Re: Stonehouse Development Co., L. L. C.
BMP Basins A, B & G Construction Certificate
Section IVA, Leather Leaf
J. C. C. Case No. S-30-97

RECORD DRAWING
C.F.
BASIN A
SECTION IVA
AT STONEHOUSE

RECORD DRAWING
OF
BASIN A
SECTION IVA
AT STONEHOUSE

Re: Stonehouse Section 4A Leather Leaf, Basin A
Dry Pond at Road near 2932 Leather Leaf
County BMP ID Code: WC 037

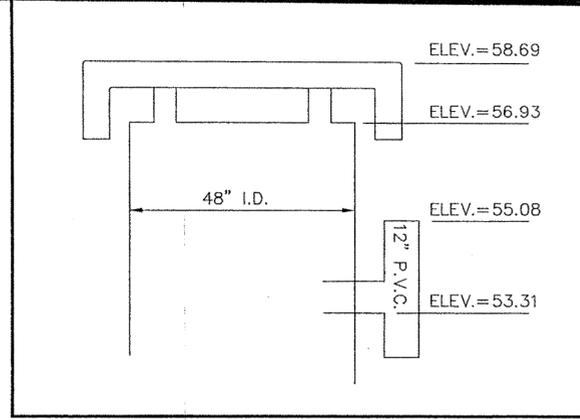
2. ~~Add the detention basin outlet structure detail as provided on Sheet 11 of the approved plan set to the as-built (record) drawing for the facility. This detail provides important information about the facility. Annotate the detail as necessary with field-obtained construction information.~~

3. Show the following additional information on the record drawing: size of riser; size of the higher level (dewatering) orifice; invert elevation on the upstream side of the low flow orifice (at the EW-11 grate) within the bottom of the pond; and show the street address on Lot 9 as 2932 Leather Leaf Drive.

4. If possible, add the following County identifiers to the lower right hand corner of the record drawing: County Plan No. S-30-97 and BMP ID No. WC 037.

REVISED PER COUNTY
COMMENTS: 2/25/03

*2-27-03
OK ✓*

*2-27-03
OK ✓*

SECTION - STATION 24+15 (BASIN A)

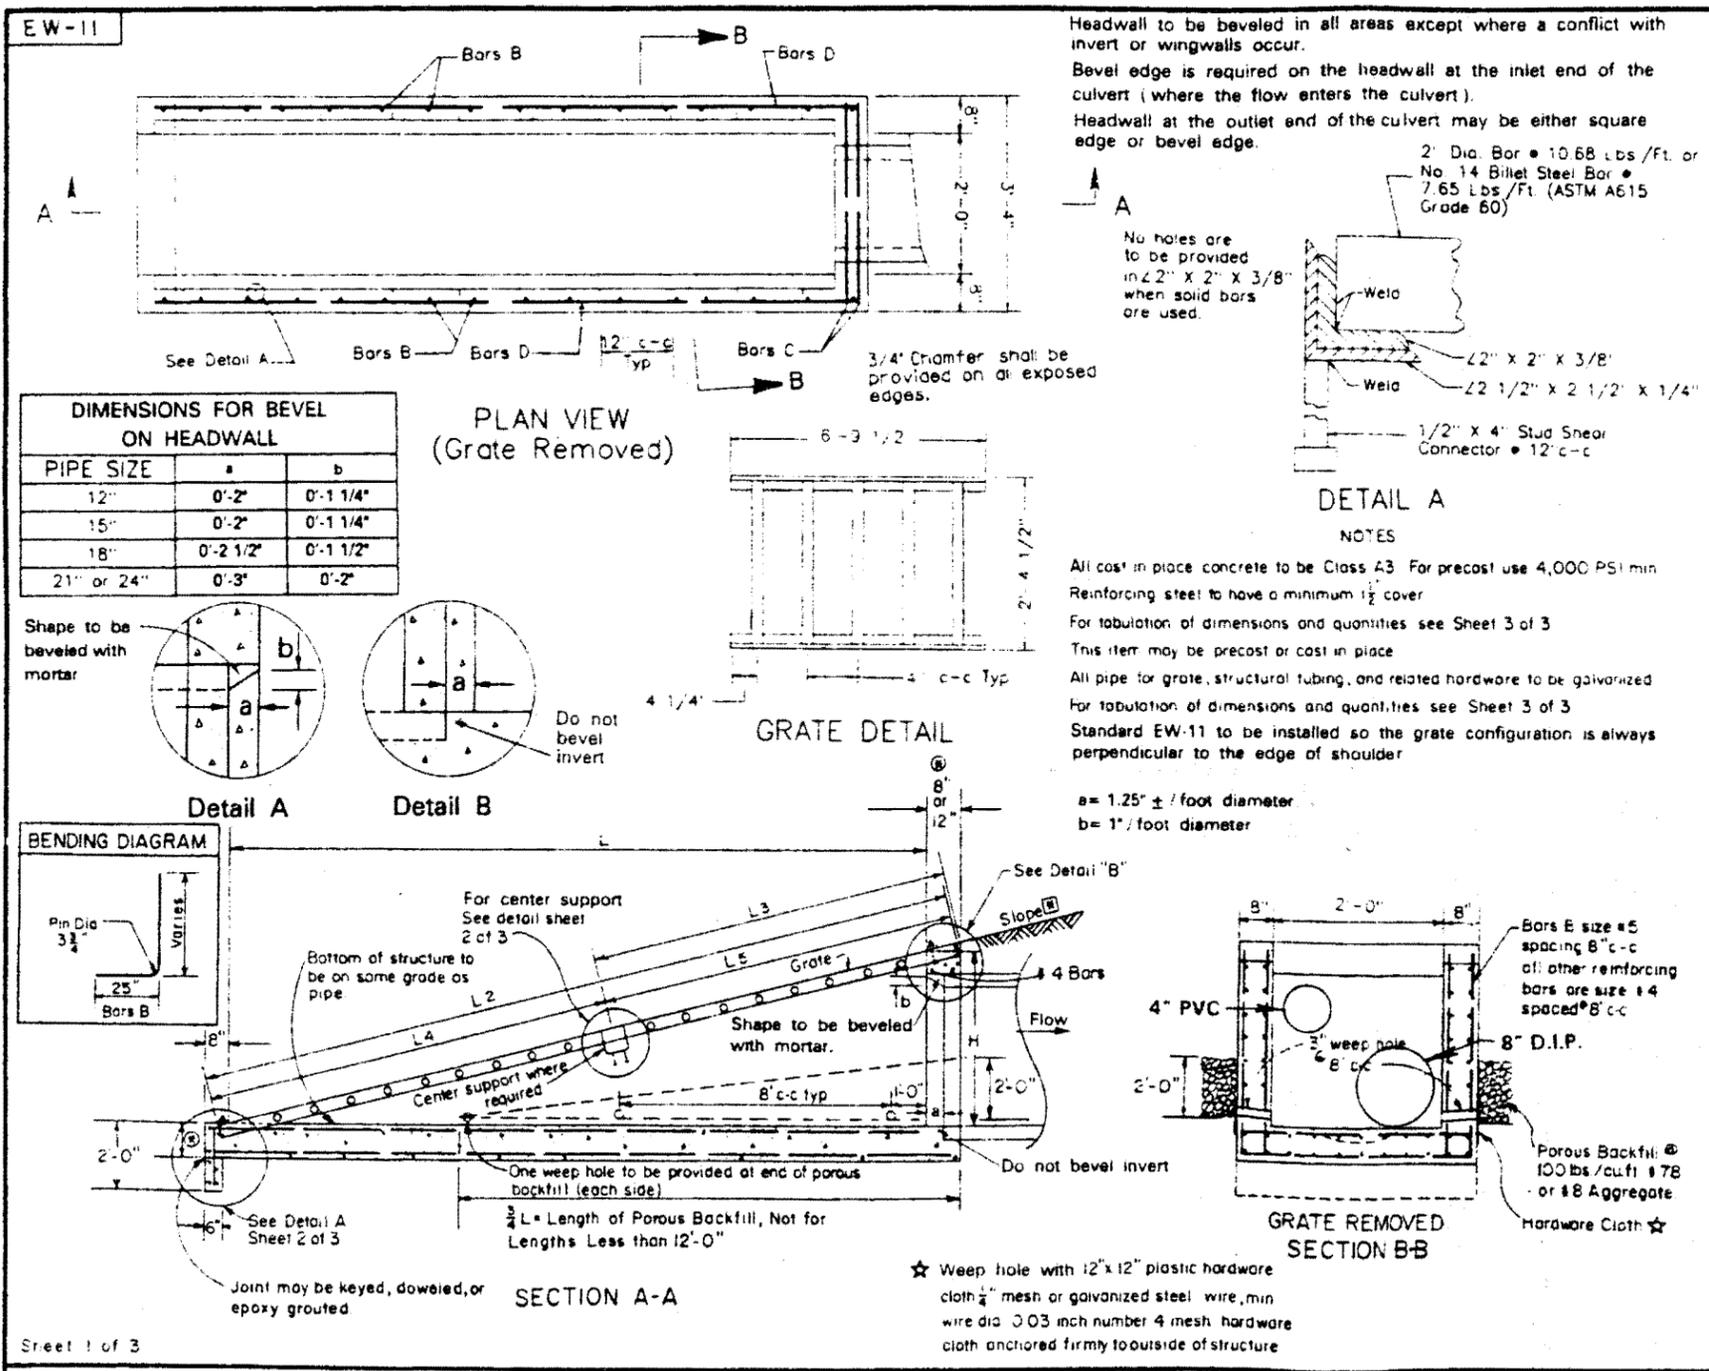
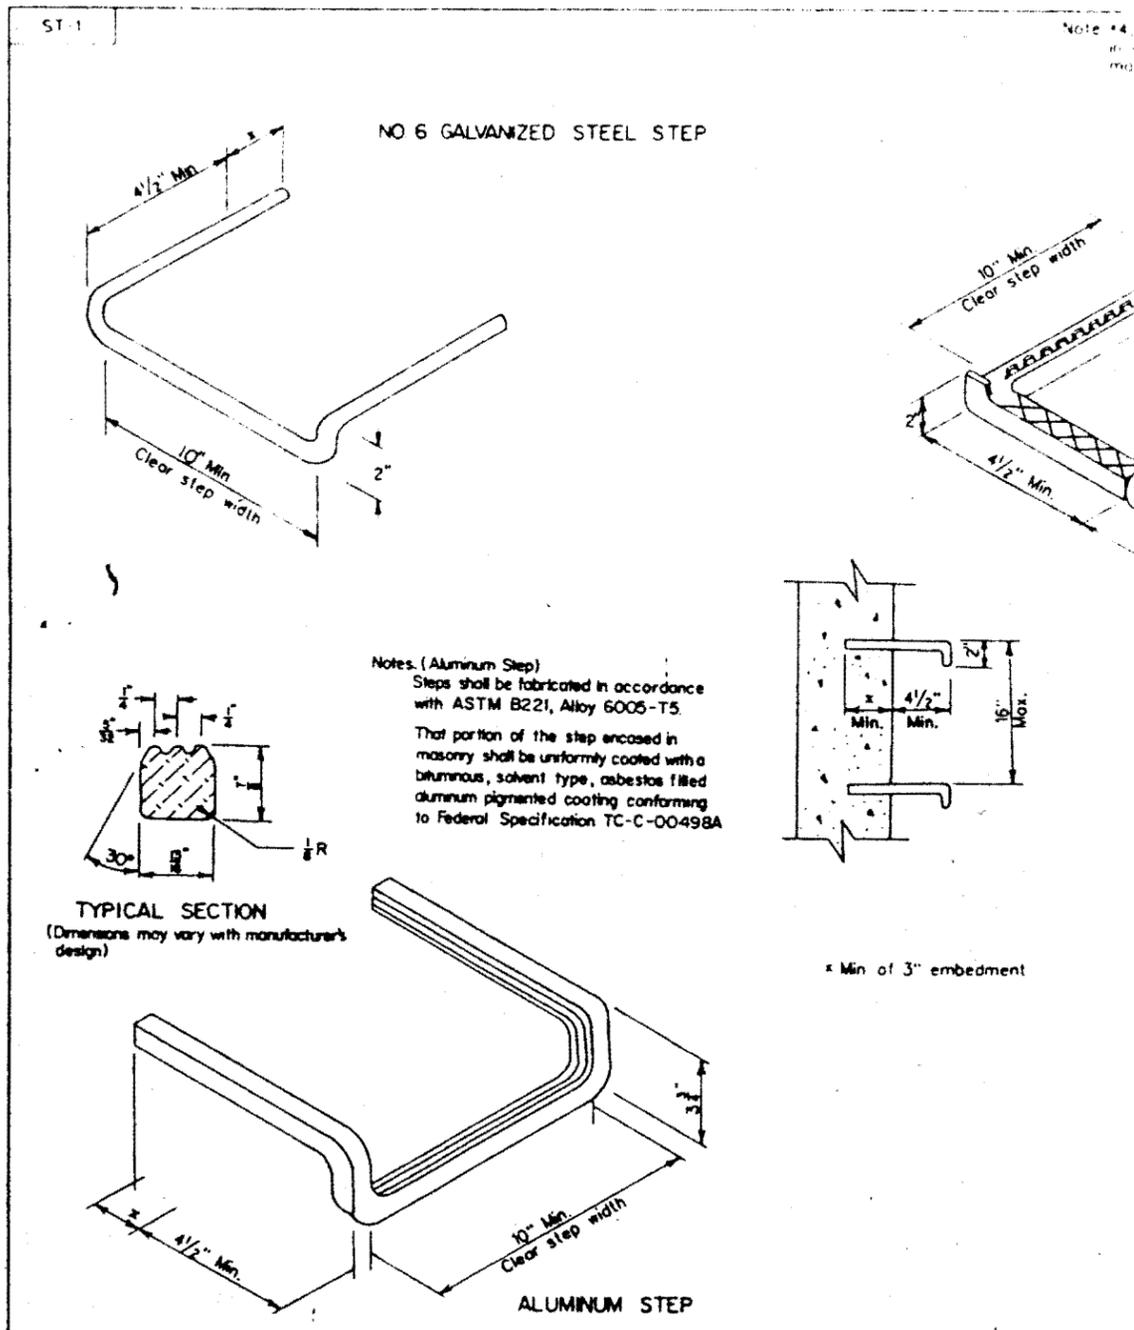
2. Add the detention basin outlet structure detail as provided on Sheet 11 of the approved plan set to the as-built (record) drawing for the facility. This detail provides important information about the facility. Annotate the detail as necessary with field-obtained construction information.
3. Show the following additional information on the record drawing: size of riser; size of the higher level (dewatering) orifice; invert elevation on the upstream side of the low flow orifice (at the EW-11 grate) within the bottom of the pond; and show the street address on Lot 9 as 2932 Leather Leaf Drive.
4. If possible, add the following County identifiers to the lower right hand corner of the record drawing: County Plan No. S-30-97 and BMP ID No. WC 037.
